TECHNICAL EVALUATION REPORT

**PRIMARY COOLANT SYSTEM  
PRESSURE ISOLATION VALVES**

SOUTHERN CALIFORNIA EDISON COMPANY  
SAN ONOFRE UNIT 1

NRC DOCKET NO. 50-206

Figure 1. Valve Configurations Designated by the NRC To Be Included in This Technical Evaluation

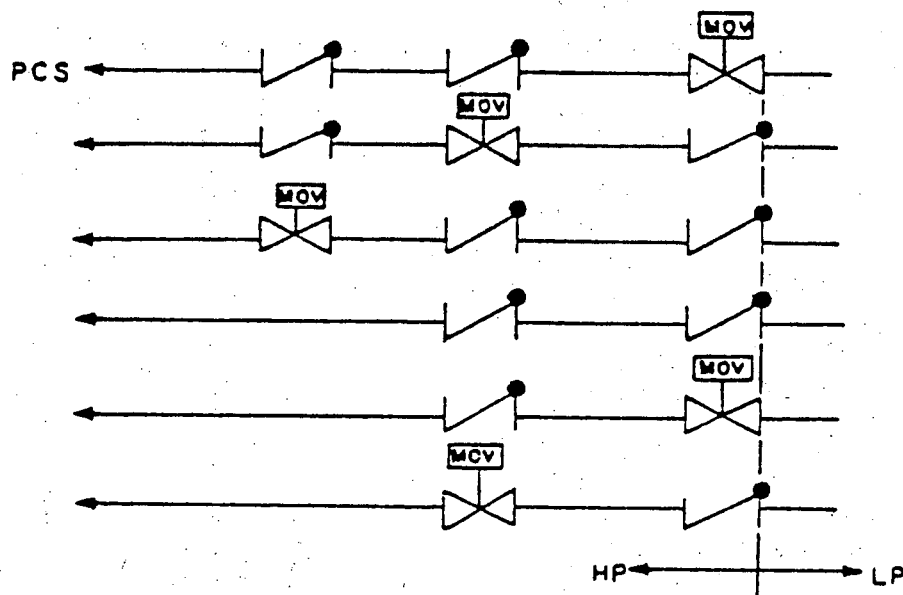
Based on the previously docketed information and drawings made available for FRC review, FRC found that the cold-leg branches of the Safety Injection System for San Onofre Unit 1 contain a valve configuration of concern (identified in Figure 1). Thus, the valve configurations of concern existing in San Onofre Unit 1 incorporate the valves listed in Table 1.0.

If SCE modifies the Plant Technical Specifications for San Onofre Unit 1 to incorporate periodic testing (as delineated in Section 2.2) for the check valves itemized in Table 1.0, then FRC considers this an acceptable means of achieving plant compliance with the NRC staff objectives of Reference 1.
